UNITED STATES PATENT AND TRADEMARK OFFICE

10/765,582

Office Action Summary	Application No.		Applicant(s)	
	10/765,582		TOTH ET AL.	
	Examiner		Art Unit	
	Chih-Cheng Glen Kao		2882

TITLE: SYSTEM AND METHOD OF X-RAY FLUX MANAGEMENT CONTROL

FIG. 14

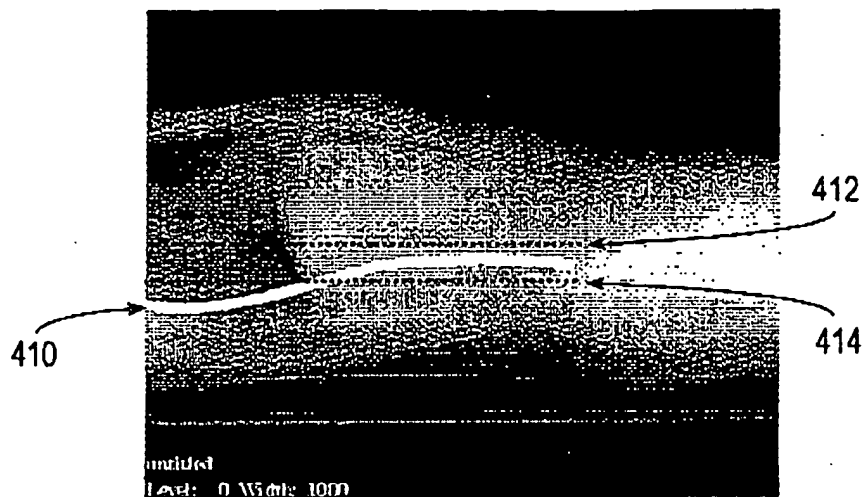
1. The drawings are objected to because the contrast in Figures 14 and 15 make them difficult to see.

Corrected drawing sheets in compliance with 37 CFR 1.121(d) are required in reply to the Office action to avoid abandonment of the application. Any amended replacement drawing sheet should include all of the figures appearing on the immediate prior version of the sheet, even if only one figure is being amended. The figure or figure number of an amended drawing should not be labeled as "amended." If a drawing figure is to be canceled, the appropriate figure must be removed from the replacement sheet, and where necessary, the remaining figures must be renumbered and appropriate changes made to the brief description of the several views of the drawings for consistency. Additional replacement sheets may be necessary to show the renumbering of the remaining figures. Each drawing sheet submitted after the filing date of an application must be labeled in the top margin as either "Replacement Sheet" or "New Sheet" pursuant to 37 CFR 1.121(d). If the changes are not accepted by the examiner, the applicant will

FIG. 18

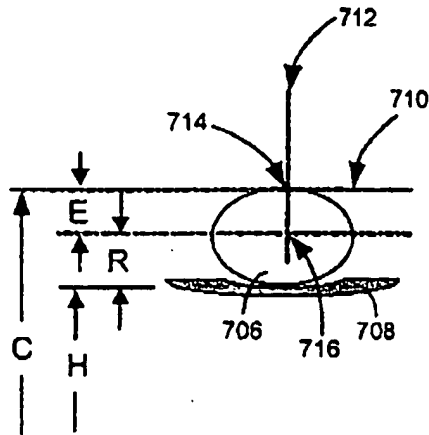
The drawings are also objected to because of the following: (equation " $E=R+H-C$ ", as defined on page 27, first paragraph, fails to correspond to fig. 18) and (equation " $E=C-R-L$ ", as defined on page 27, second paragraph, fails to correspond to fig. 19). The equation " $E=R+H-C$ " is equivalent to $E+C=R+H$. However, as seen in Figure 18, $E+C$ fails to equal $R+H$. Likewise, the equation " $E=C-R-L$ " is equivalent to $E+R+L=C$. However, as seen in Figure 19, $E+R+L$ fails to equal C .
